HIGHWAY LIGHTING LEGEND
& KEY MAP

INTERSTATE ROUTE H-1 REHABILITATION
MIDDLE STREET TO VICINITY OF WARD AVENUE
FAP NO. 1M-HI-1(269)

"AS-BUILT"

HIGHWAY LIGHTING PLAN - L

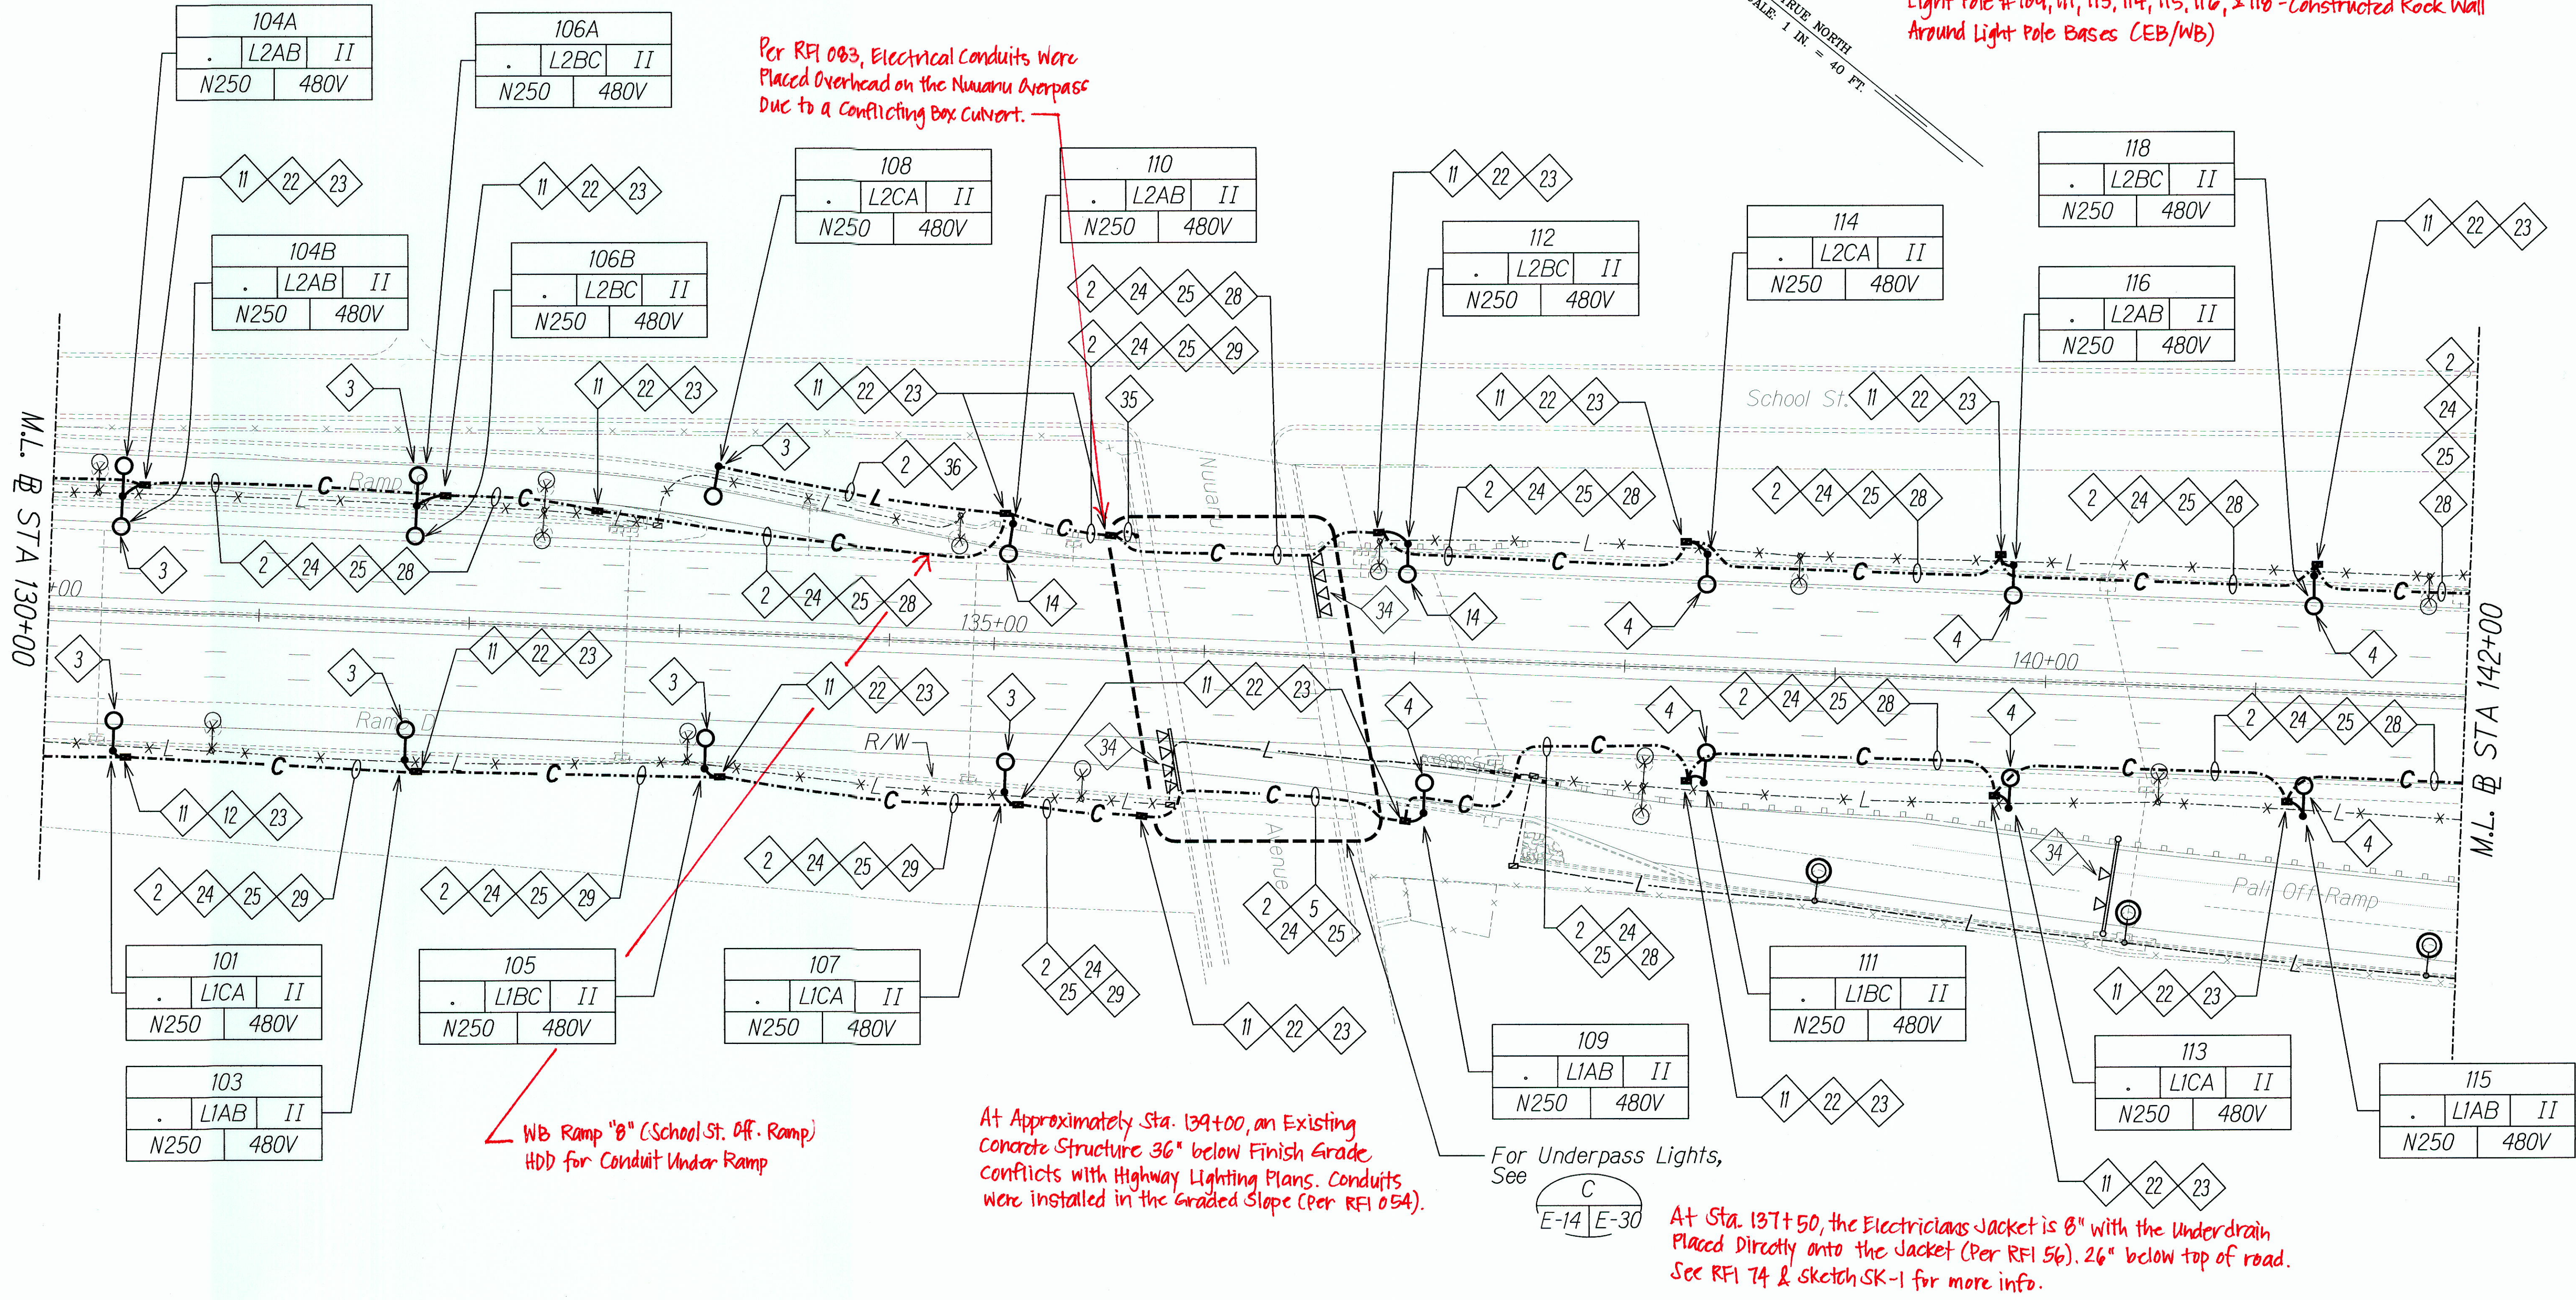
New Single Arm Pole Provided for 104A, and Bracket Arm Removed on 104B to Create a Single Arm Pole. See RFI 154 for more details.

Same Instance Occured for 106A & 106B. With a New Single Arm Pole for 106A Per RFI 161.

Per RFI 066, Light Pole 112 and Handhole Were Relocated to 10 to 15 ft. East (Right Side) of the Existing Light Pole.

Light Pole # 109, 111, 113, 114, 115, 116, & 118 - Constructed Rock Wall Around Light Pole Bases (CEB/WB)

HIGHWAY LIGHTING PLAN
STA 142+00 TO 153+00

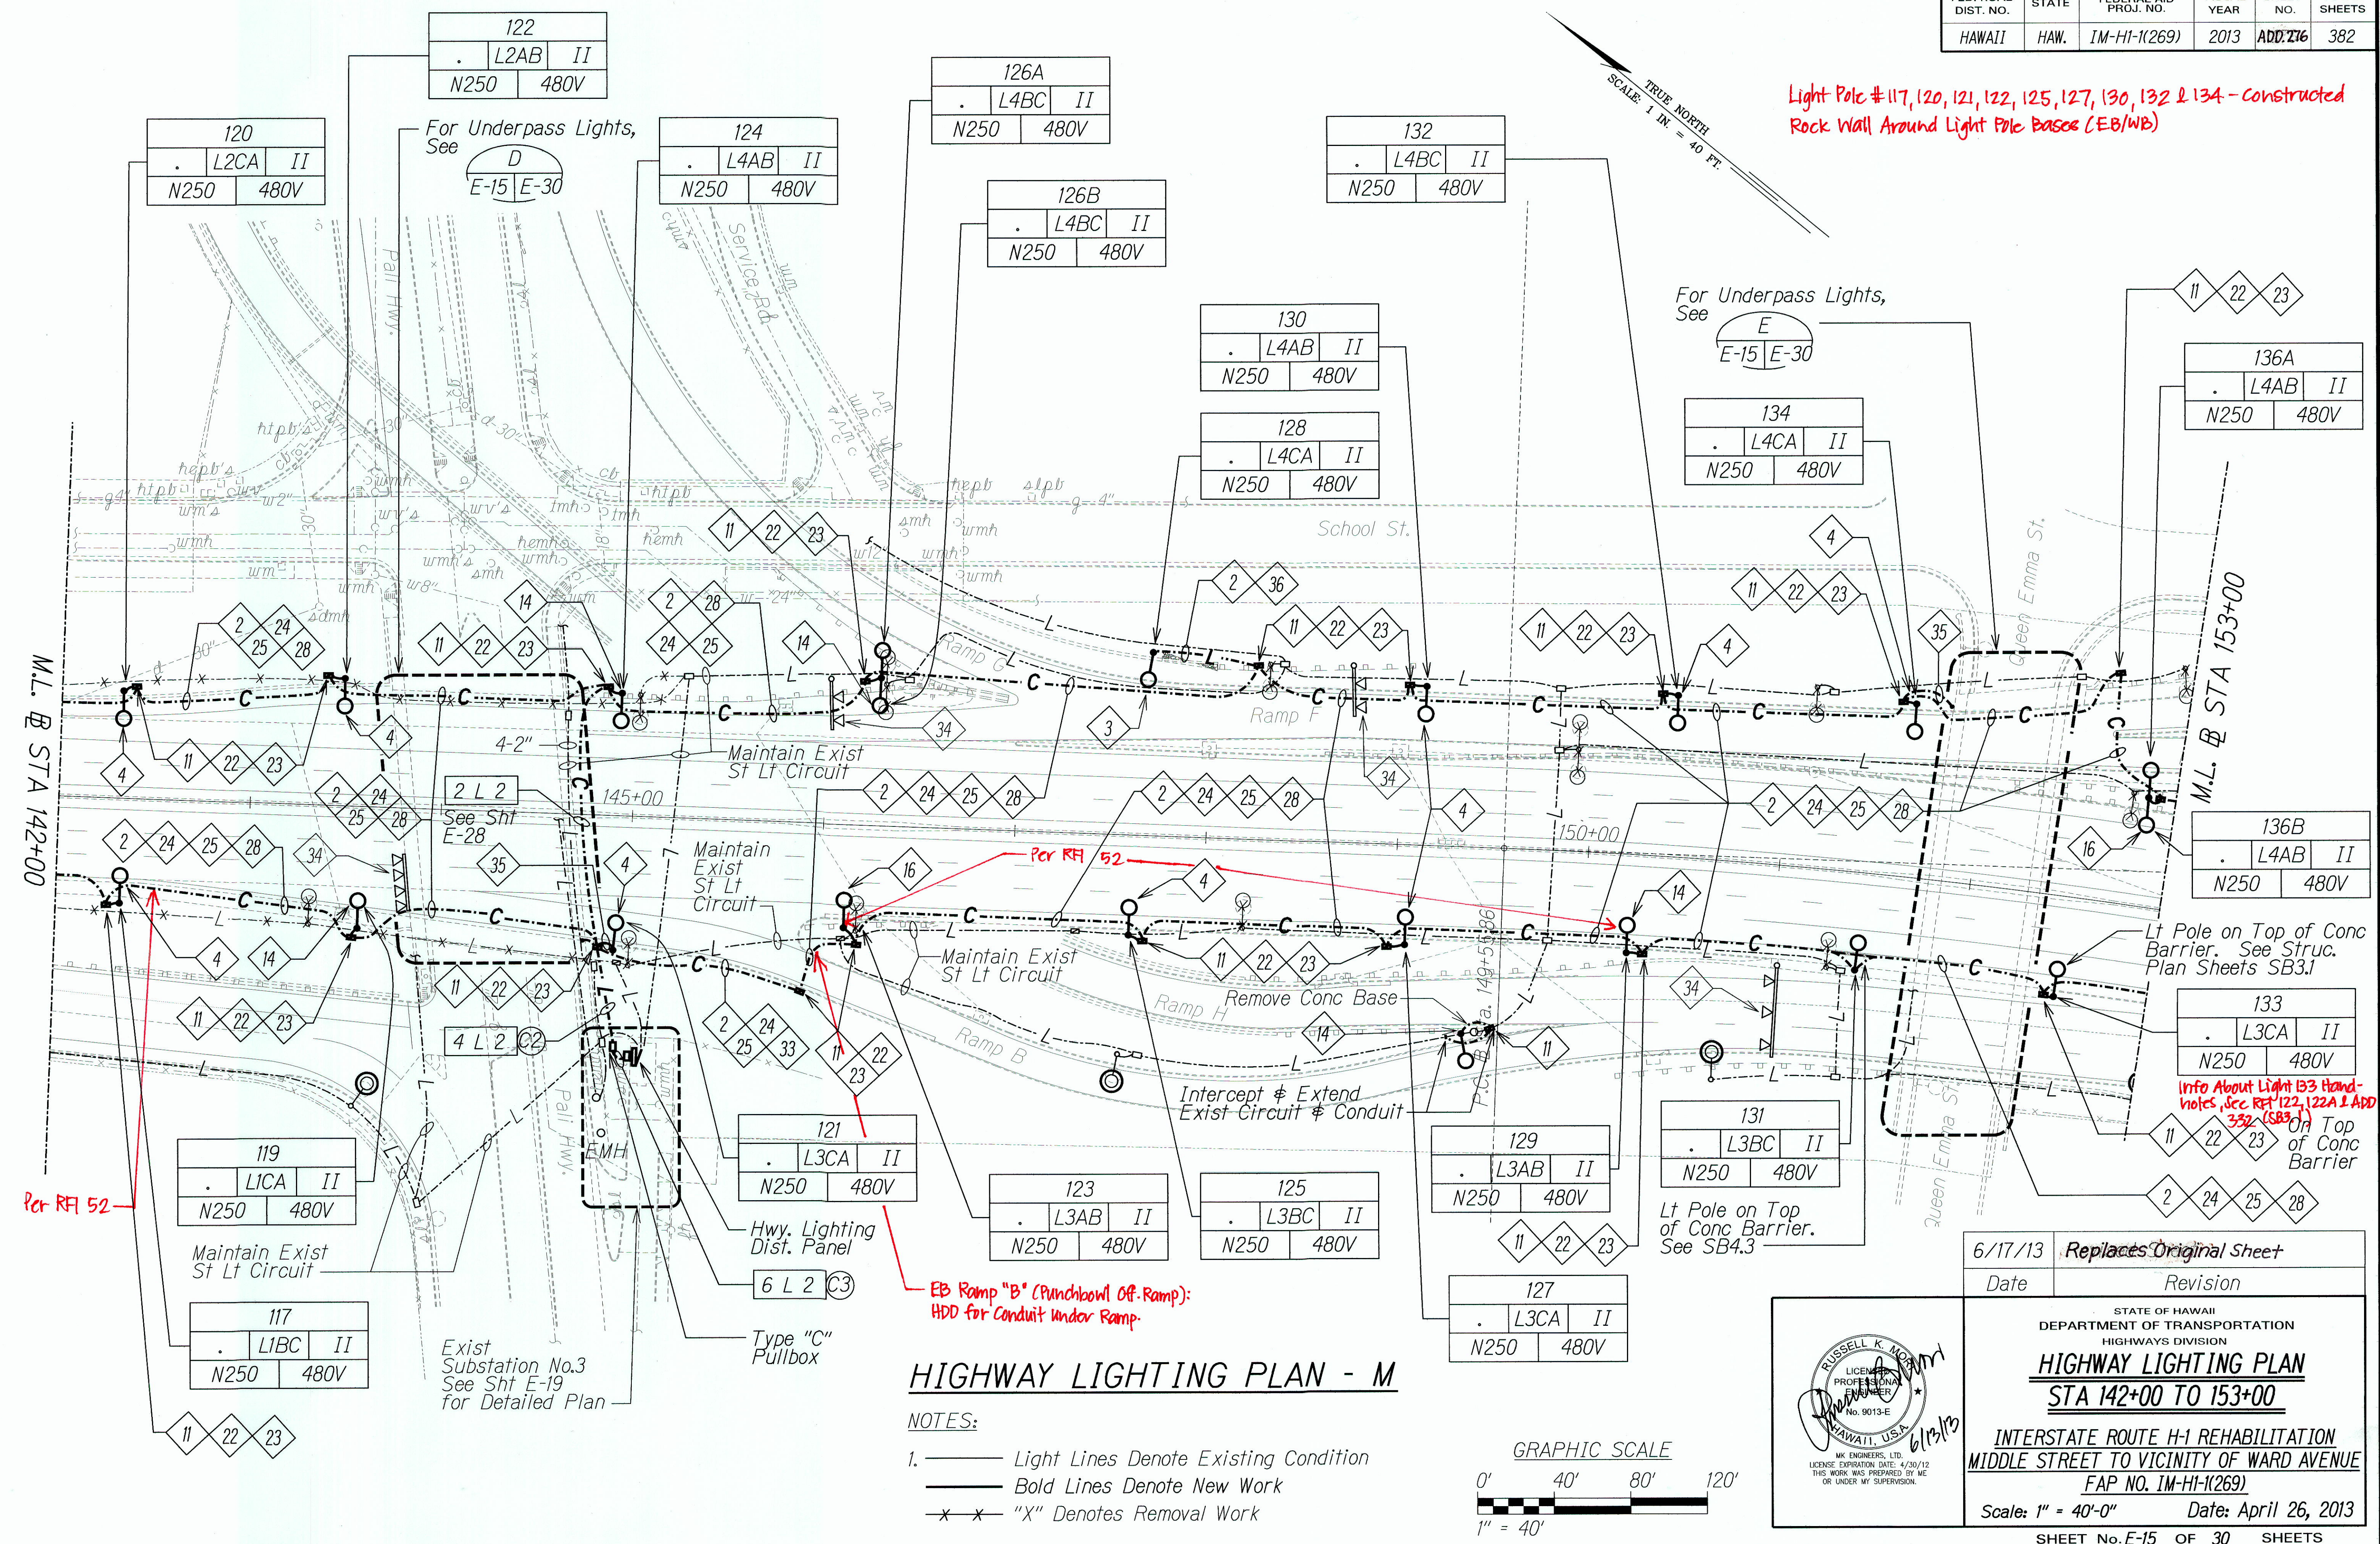
Light Pole #117, 120, 121, 122, 125, 127, 130, 132 & 134 - Constructed Rock Wall Around Light Pole Bases (EB/WB)

DUCT SECTION (D)
NTS

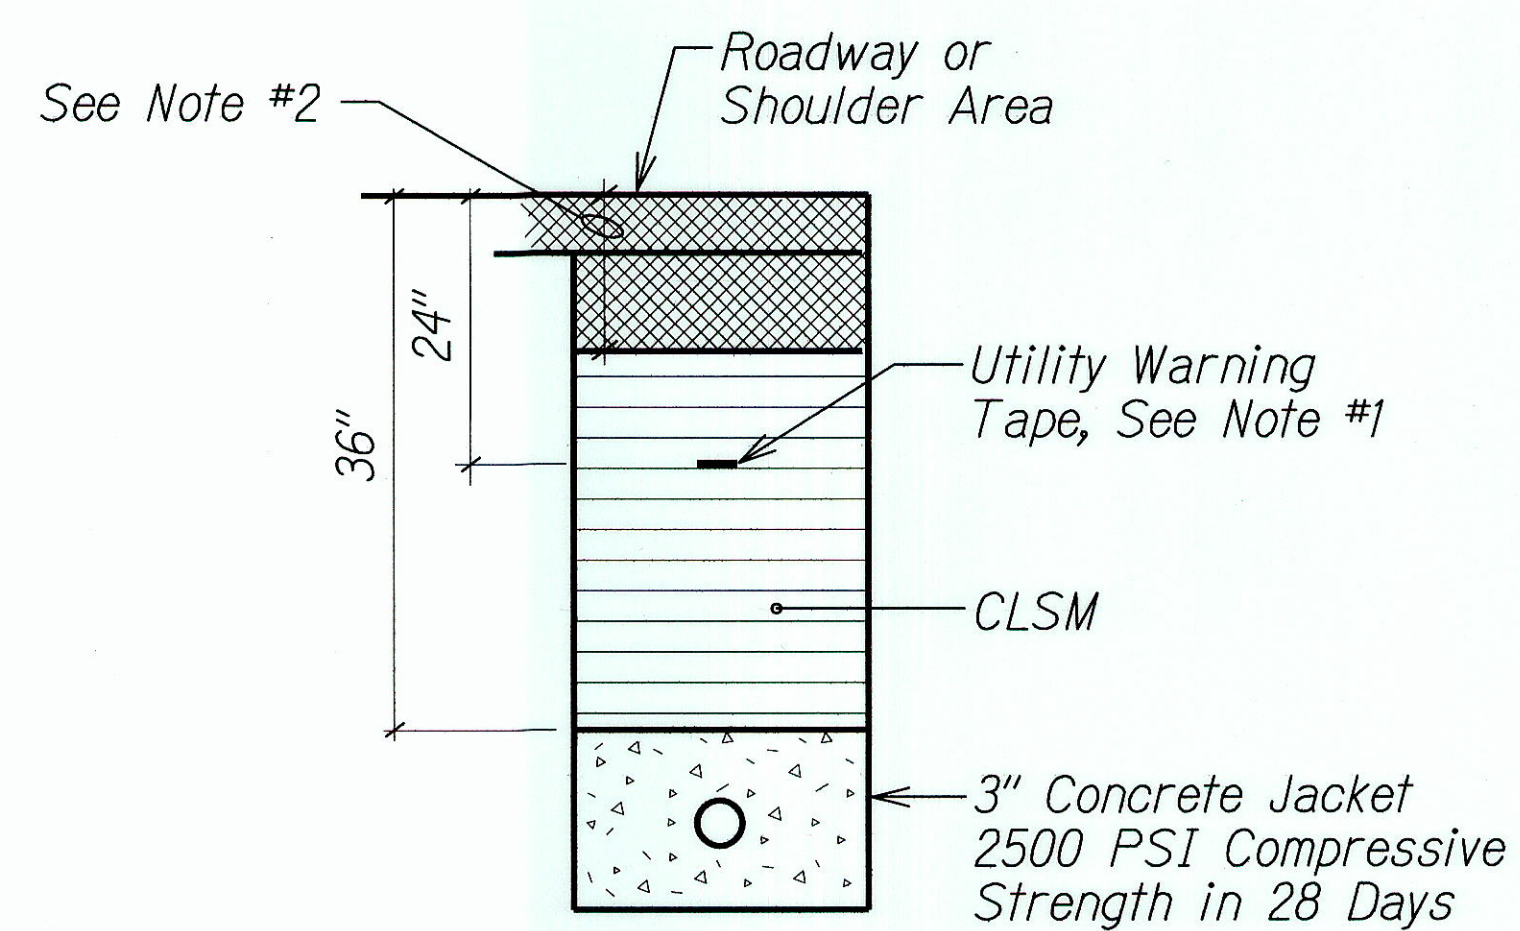
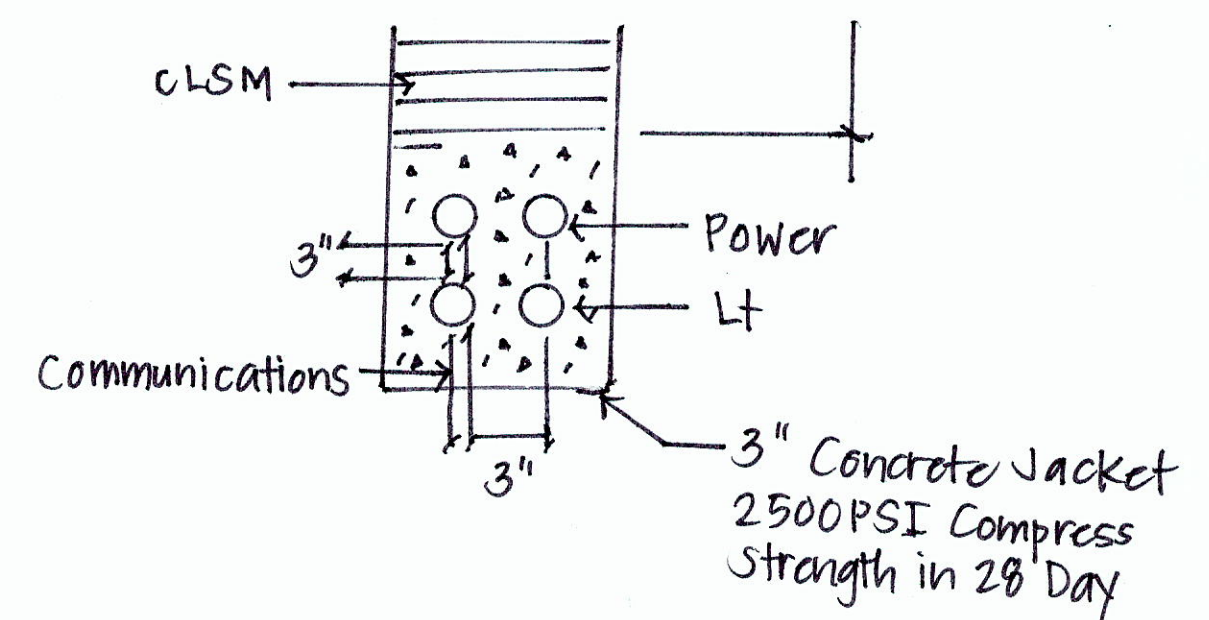
The Flat Duct Configuration was changed to a Stacked Configuration (Per RFI 018).

As a Bond Breaker, #15 Roofing Felt Was Used Between the Concrete Jacket and CLSM Backfill. (See RFI # 24, 24B For Info)
